Technical Service BULLETIN

SQUEAK NOISE FROM FRONT OF VEHICLE

'00 MR2 Spyder

NAV
00-8008-00

Production Change Information

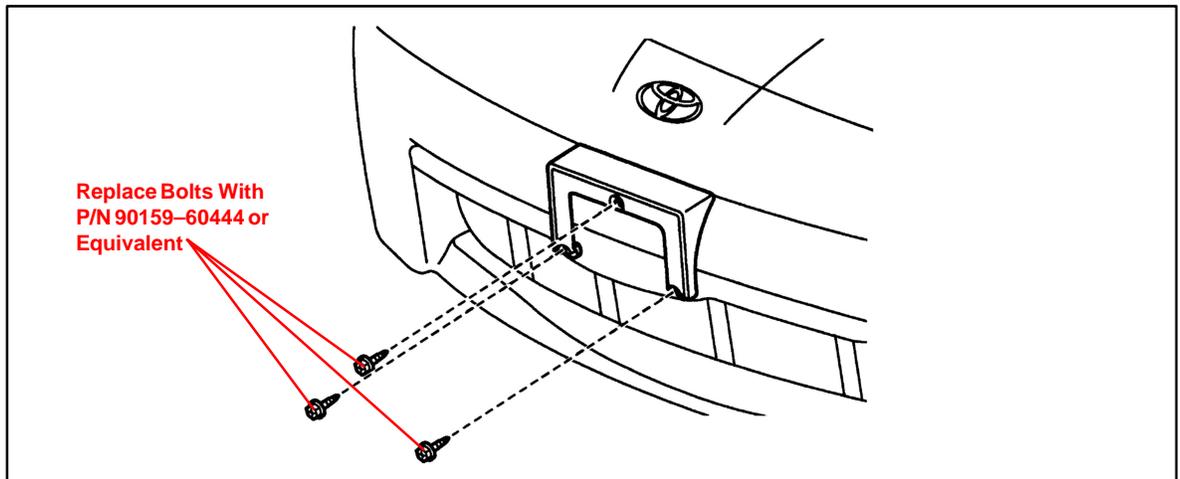
Introduction Shorter front license plate bracket mounting bolts have been adopted to prevent the possibility of a squeak noise from the front of the vehicle.

Replace the front license plate bracket mounting bolts with P/N 90159-60444 or equivalent (M6 x 2.5 x 20 mm).
